OFFICE BUILDING SHELL
DRB RESUBMITTAL
2022-04-27

DEVELOPMENT REVIEW BOARD
SUPPLEMENTAL SUBMITTAL

Re: Resubmittal for a Major Amendment for Site Development Plan for Building Permit for the Proposed New Construction for Tract 5-A-1, Block C, Louisiana Subdivision at 2440 Louisiana Boulevard NE

COMMENTS & REPLIES

A2 SITE PLAN 1" = 20'-0"

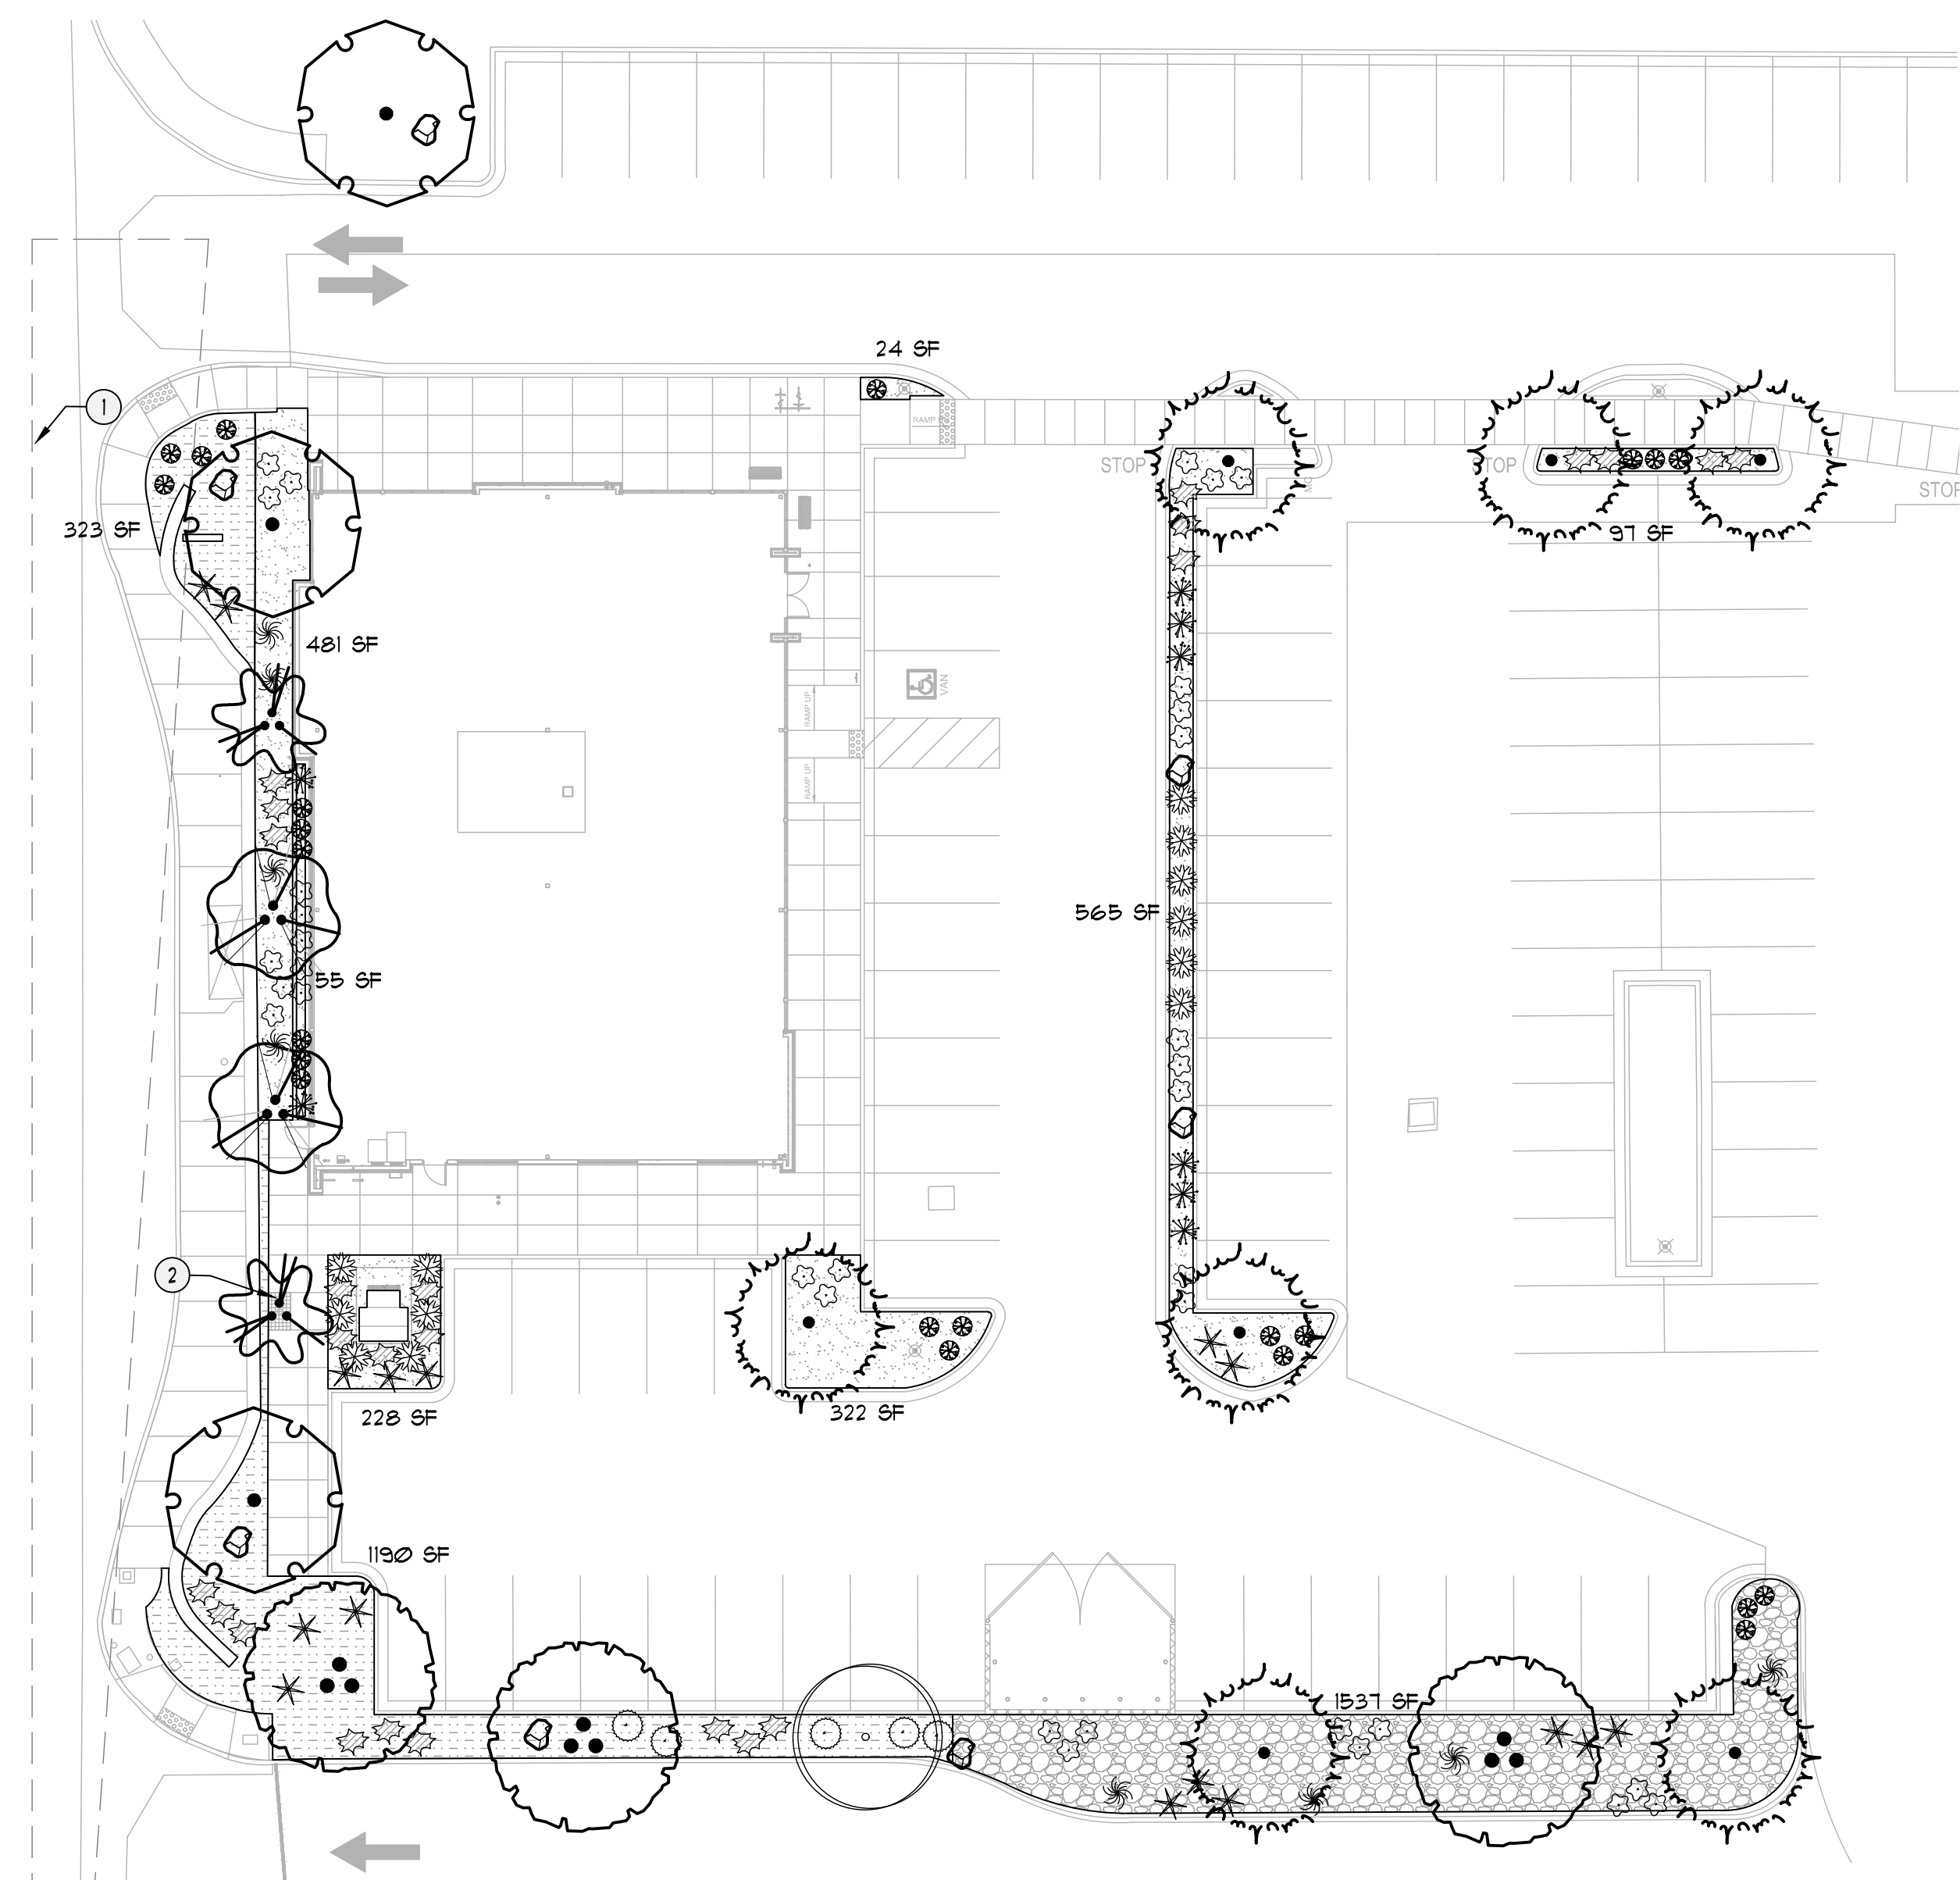
- a. **Response: The Infrastructure List now shows a sidewalk width range of 8'-10'.**
2. Show Tract Numbers on the site plan that match those referenced within the Shared Access Agreement. The Tract numbers are unclear.

- a. **Response: The Site Development plan now shows the Tract numbers.**
3. The existing monument sign looks to be outside of the public right-of-way according to the site plan, but the comments state otherwise. Please verify. For any private infrastructure located within public right-of-way, a revocable permit will be needed.

- a. **Response: Our client has chosen to pursue a revocable permit**
4. Use keyed note to call out clear sight triangle on the site plan and on the landscaping plan. Use standard note to limit landscaping height within these areas on both plans.

1. Confirm if any freestanding signage is proposed.
 - a. **Response: Keynote 15 at the southeast corner of the site indicates the location of a new directional sign. No other new signage is proposed except for accessible space and motorcycle parking signage.**

- a. **Response: This has been done on both plans.**
5. Note 16 is blank. It looks like this is the note that calls out the bike rack area.
 - a. **Response: This keynote has been fixed.**

Landscape Plan

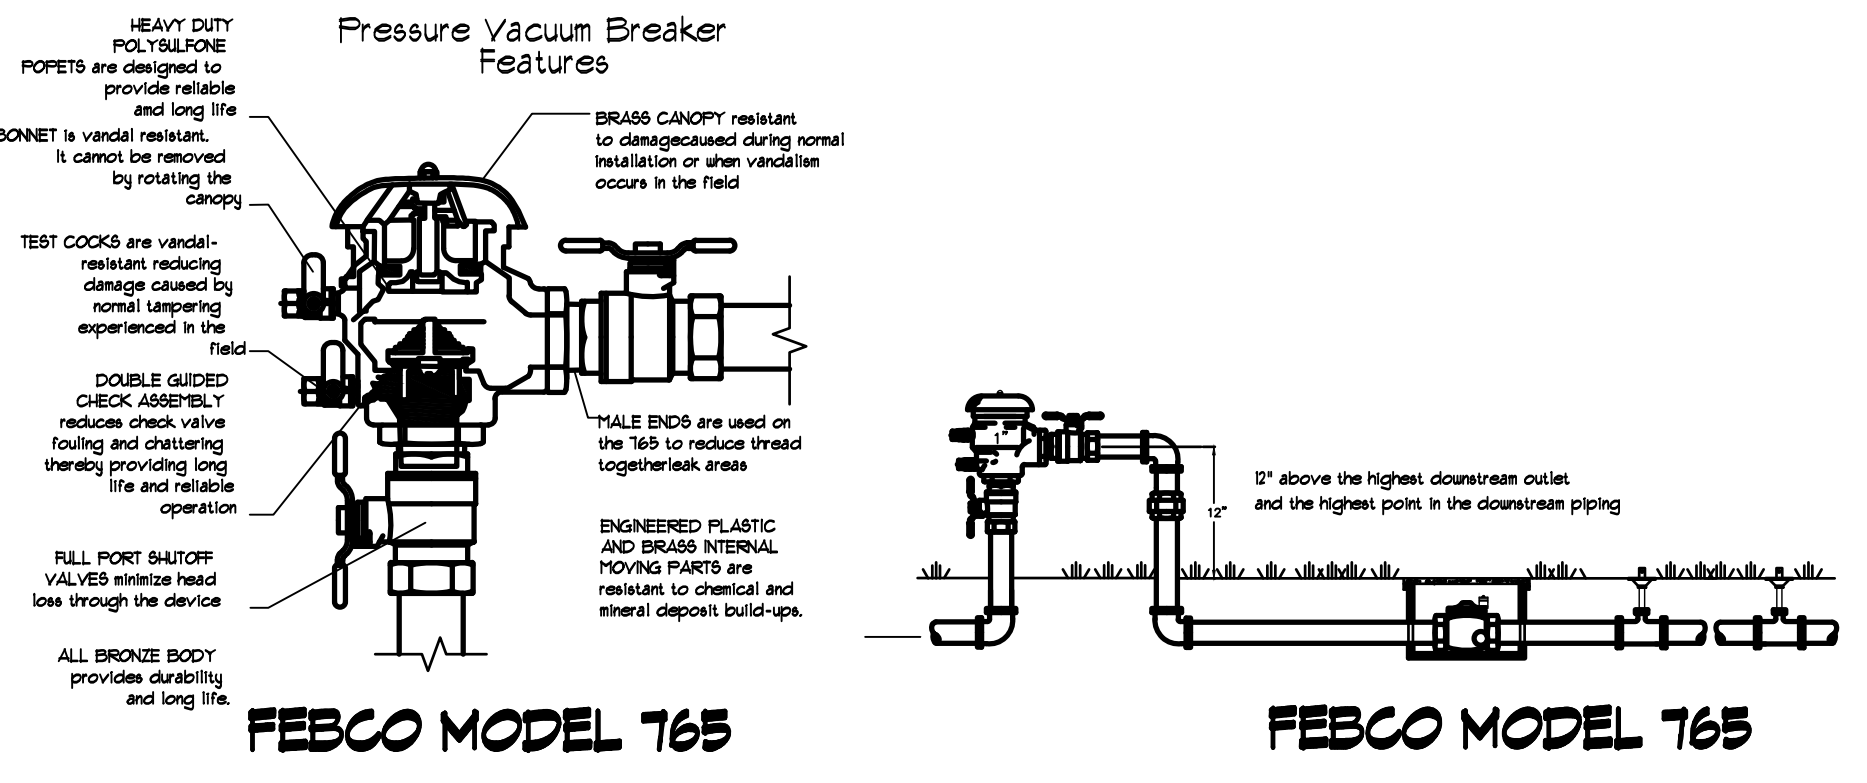
2. Confirm if sufficient street frontage landscaping is provided per 5-6(D) of the IDO.
 - a. **Response: Confirmed. See the Note on Sheet 05.**
3. The walls/fences proposed on the Site Plan Amendment must meet 507(D) of the IDO, including the enclosure.

7. The applicant has met the building façade requirements outlined in IDO 5-11(D).
8. Remove any reference to trees per multi-family unit from the landscaping plan.
 - a. **Response: We don't see this reference on the new landscaping plan. Is it possible that this is referring to the original landscaping plan produced by DPS?**

STREET FRONTAGE TREES MEET 25' REQUIREMENT FROM IDO 14-16-5-6(D.11)

PLANTINGS WITHIN THE CLEAR LINE OF SIGHT TRIANGLE MUST NOT BE BETWEEN THE HEIGHT RANGE OF 2'-8" TALL, IF IT IS LESS OR MORE THAN THAT HEIGHT IT CAN REMAIN IN THE AREA.

A1 CONCEPTUAL GRADING & DRAINAGE PLAN
 1" = 20'-0"

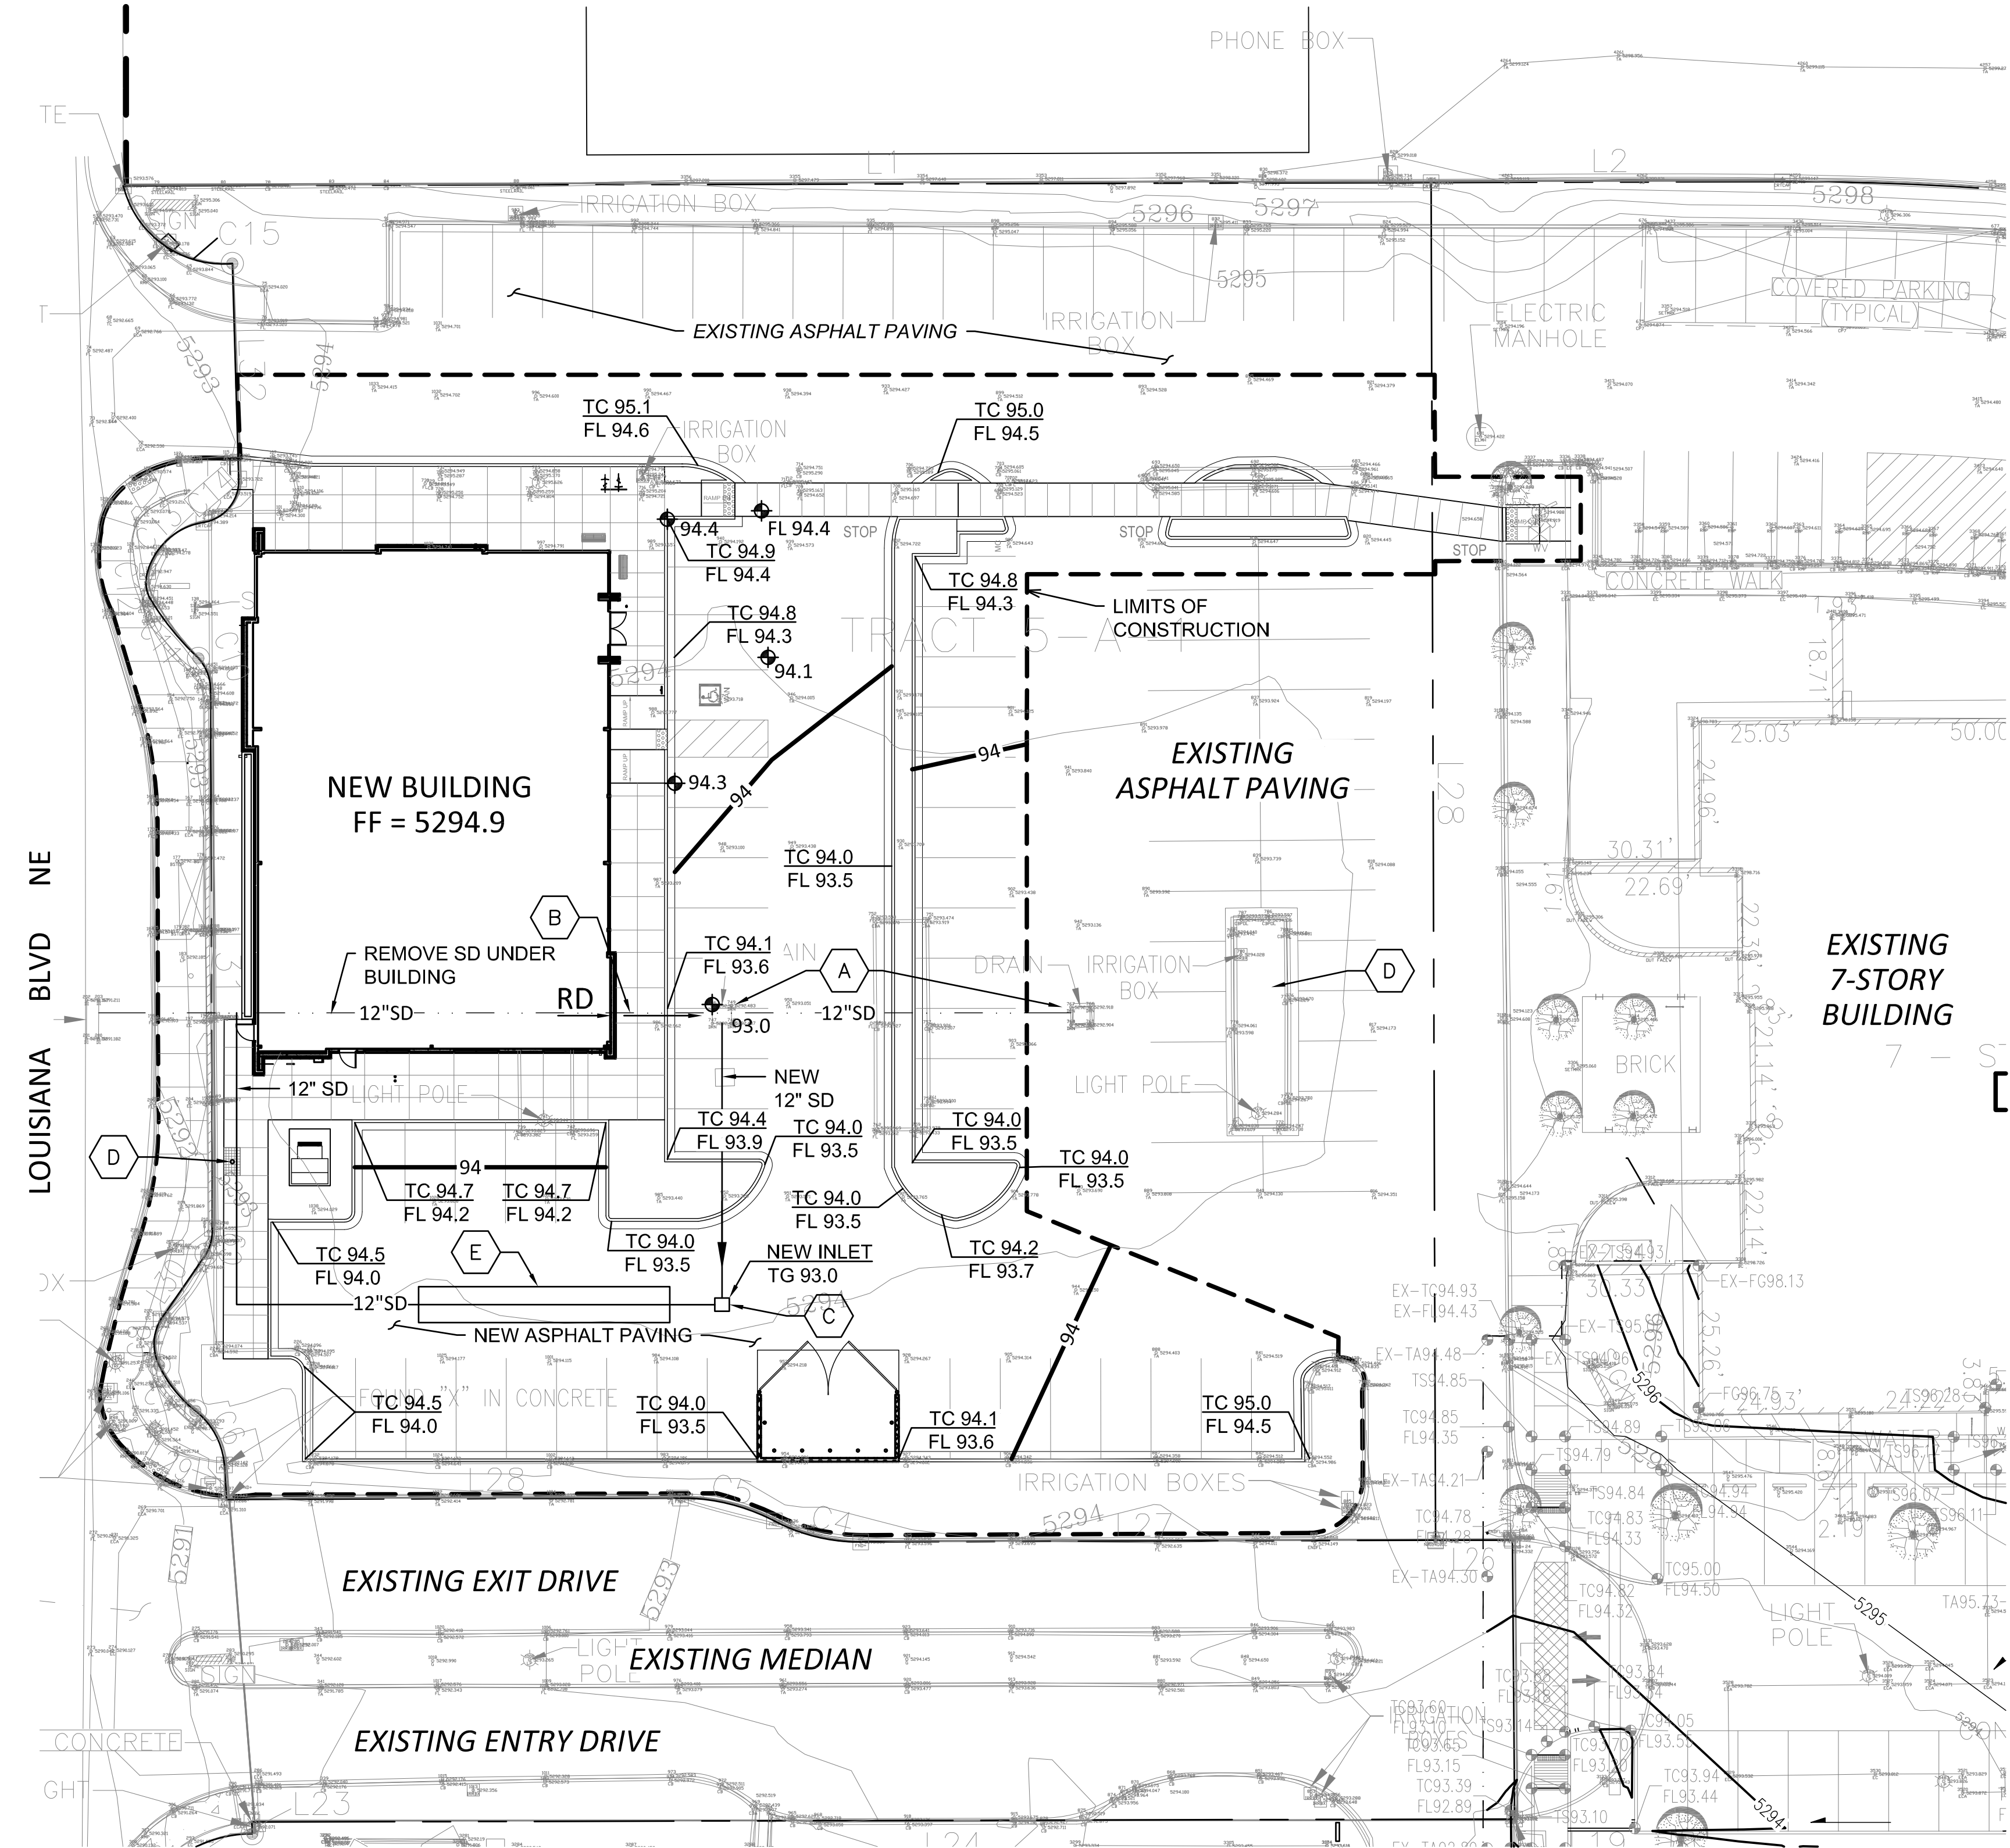
1. Hydrology needs an approved Grading and Drainage Plan prior to approval of Site Plan for Building Permit Amendment.

- a. **Response: Hydrology approval received. See attached plan and letter.**
2. Hydrology received a re-submittal (H19D084) on April 1, 2022 based on a comment letter.
 - a. **Response: Hydrology approval received. See attached plan and letter.**
3. Hydrology recommends a four-week deferral.
 - a. **Response: Hydrology approval received. See attached plan and letter.**

Based upon the information provided in your submittal received 03/31/2022, the Conceptual Grading & Drainage Plan is approved for action by the DRB on Site Plan for Building Permit.
